CCU Change Order Request East Port WRF Expansion - Poole and Kent Change Order #10			
Date:	4/14/2027	Original Contract Time:	900
Contract Number:	2023000485	Additional Time:	0
Original Contract Price:	\$106,188,600.00	Previous Changes:	198
Previous Change Orders:	\$1,574,855.20	New Contract Time:	1,098
This Change:	\$23,935.07		
Revised Contract Amount:	\$107,787,390.27		
Contract Start Date:	1/22/2024		
Current Completion Date:	1/24/2027		
New Completion Date:	1/24/2027		
Purchase Order Number:	2024000830

Subject: P&K PCO #53A Additional Clarifier Splitter Box
Coatings P&K PCO No. 53A

PROJECT NAME: Charlotte County Utilities East Port Water Reclamation Facility (WRF) 9 MGD Expansion

Attn: Hendrik Dolleman
Re: Eastport WRF MGD Expansion Project
Contract Number: 18-0006
Poole & Kent Project No. 24801
Subject: PCO 54 – MCC 5B & 6B Bucket Conversion for Bard Unit 480V Power
P&K PCO No. 54

MCC-5B FRONT ELEVATION

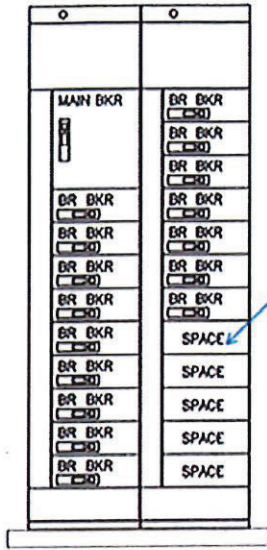
Since there are 2 bard units, we are going to have to add a 15A 480 VAC 3Pole HACR rated circuit breaker to MCC-5B and MCC-6B
